SOIL/SITE EVALUATION

FOR ON-SITE WASTEWATER SYSTEM

LOCATION OF SITE: Lot # 32
 WATER SUPPLY: On-Site Well _____ Comm. Well _____ Public _____ Other _____ EVAL. METHOD: Auger Boring _____ Pit _____

Plot # 32

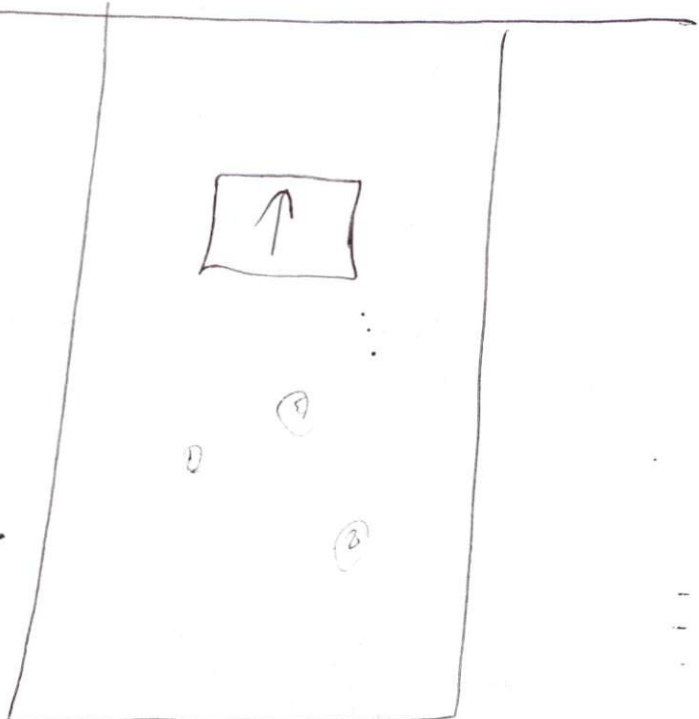
Need plot
Plan to see
if Repair Area
is okay.
